**PLANNED UNIT DEVELOPMENT,
PLANNING APPROVAL &
SUBDIVISION STAFF REPORT**

Date: December 6, 2007

<u>DEVELOPMENT NAME</u>	St. Dominic Catholic Church
<u>SUBDIVISION NAME</u>	St. Dominic Catholic Church Subdivision
<u>LOCATION</u>	4068, 4156, & 4160 Burma Road and 1168 Santa Maria Court (North side of Burma Road, between Santa Maria Court and St. Dominic Place)
<u>CITY COUNCIL DISTRICT</u>	District 4
<u>PRESENT ZONING</u>	R-1, Single-Family Residential
<u>AREA OF PROPERTY</u>	1 lot/ 13.0± Acres
<u>CONTEMPLATED USE</u>	Planned Unit Development approval to allow multiple buildings on a single building site, Planning Approval to amend a previously approved Planning Approval to allow the expansion of an existing church in an R-1, single-Family Residential District, and Subdivision approval to create one lot.
<u>TIME SCHEDULE FOR DEVELOPMENT</u>	Immediately
<u>ENGINEERING COMMENTS</u>	It is the responsibility of the applicant to look up the site in the City of Mobile (COM) GIS system and verify if NWI wetlands are depicted on the site. If the COM GIS shows wetlands on the site, it is the responsibility of the applicant to confirm or deny the existence of wetlands on-site. If wetlands a

SITE PLAN

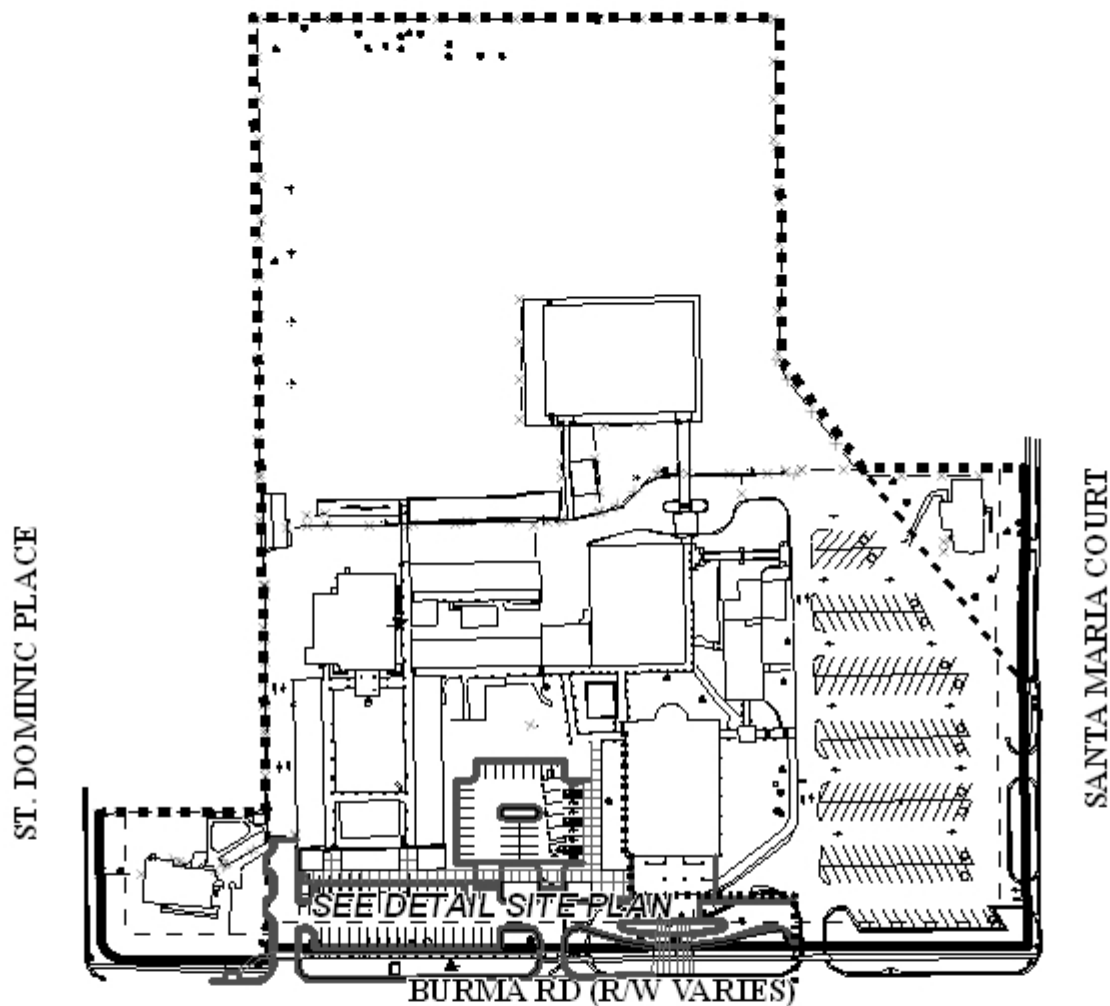
Staff is not able to determine if the proposed additional parking spaces illustrated are required spaces and if the additional parking will impact the traffic circulation for the campus or for the area where the proposed parking ties into the existing facilities. It should also be pointed out that the proposed parking will further reduce the front landscaping requirement and may impact existing trees within the area of the proposed parking. It should also be noted that the existing parking along Burma Road is illustrated within the right-of-way and sidewalks are not illustrated within this area. It should be indicated that sidewalks would be required for any significant construction or redevelopment to the site.

No on-site storm water detention facilities are depicted on the site plan, however such facilities may be required due to the extent of the proposed new development. After consultation with the

Engineering Department, the site plan should be revised to depict any required on-site storm water detention facilities.

There is no indication on the site plan as to the proposed location of any dumpster or other waste storage facility. Visual inspection of the site indicates that dumpsters are located on the Southeast corner of the property, and are currently unscreened. The location of the storage area for the dumpster must be indicated on the site plan, and the location and required screening must comply with Section 64-4.D.9. of the Zoning Ordinance, as well as with all other applicable regulations.

The site plan should also be revised to depict the existing parking and vehicular circulation for the remainder of the site.

Regarding compliance with the tree and landscape requirements of the Zoning Ordinance, the applicant should explore opportunities to add frontage trees and landscaping along Burma Road, if possible.

As the new construction will be adjacent to existing residences, the applicant should ensure that any lighting provided on the site will comply with the Zoning Ordinance requirement that states that lighting *"shall be so arranged that the source of light does not shine directly into adjacent residential properties or into traffic."* Therefore, the application should provide photometric information for electrical requirements.

3. revision of the site plan to depict existing and proposed dumpster storage locations, in compliance with Section 64-4.D.9. of the Zoning Ordinance;
4. revision of the site plan to depict existing and proposed new parking, and on-site circulation;

5. placement of a note on the site plan stating that lighting shall be so arranged that the source of light does not shine directly into adjacent residential properties or into traffic;

6. revision of the site plan to accurately depict all existing curb-cuts, and modifications thereof , as well as proposed curb-cuts;
7. revision of the site plan to provide frontage trees and landscaping along Burma Road, where possible;

8. the depiction of the existing frontage landscape and the proposed frontage landscaping of the new parking layout;
9. submission of information of the use and hours of operation for the building along Santa Maria Court; and

3. revision of the site plan to depict existing and proposed dumpster storage locations, in compliance with Section 64-4.D.9. of the Zoning Ordinance;
4. revision of the site plan to depict existing and proposed new parking, and on-site circulation;

5. placement of a note on the site plan stating that lighting shall be so arranged that the source of light does not shine directly into adjacent residential properties or into traffic;

6. revision of the site plan to accurately depict all existing curb-cuts, and modifications thereof , as well as proposed curb-cuts;
7. revision of the site plan to provide frontage trees and landscaping along Burma Road, where possible;

8. the depiction of the existing frontage landscape and the proposed frontage landscaping of the new parking layout;
